PRODUCT SUPPORT BULLETIN NO. 208

MACHINE: All Hydra-Hammers, Hydra-Spikers, Super Claws,
Grabbers, and Anchor Applicators

SUBJECT: ELECTRIC HORN KIT

HORN INSTALLATION KIT

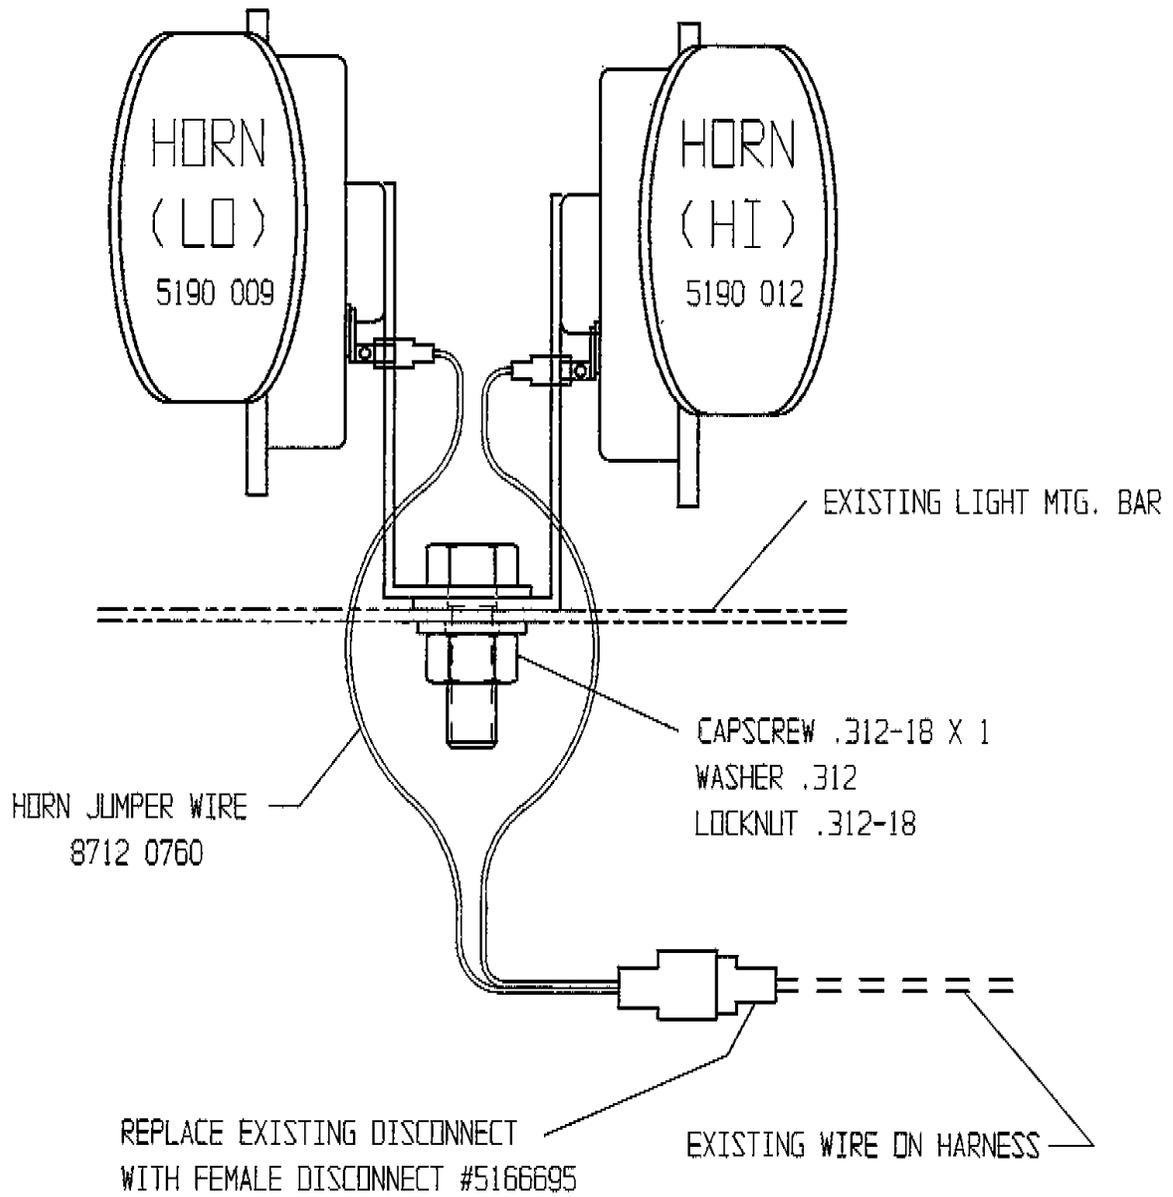
A Horn Kit (Nordco Part Number 9843 0110) has been set up to replace either the automotive type horn or air horn presently used on Nordco Equipment. The present horns are single tone and may blend in with background noise. The 9843 0110 Horn Kit has one low pitch and one high pitch horn, which makes it stand out from the background noise. The kit includes mounting hardware, a jumper wire and a disconnect so the new horns may use the existing horn wire when installed. See Illustration other side of page.

One of the 9843 0110 Horn Kits should be installed on each end of the machine, so two kits per machine would be required.

The new dual pitch horns will be standard on future Nordco equipment and can be retrofit on any Nordco machine.
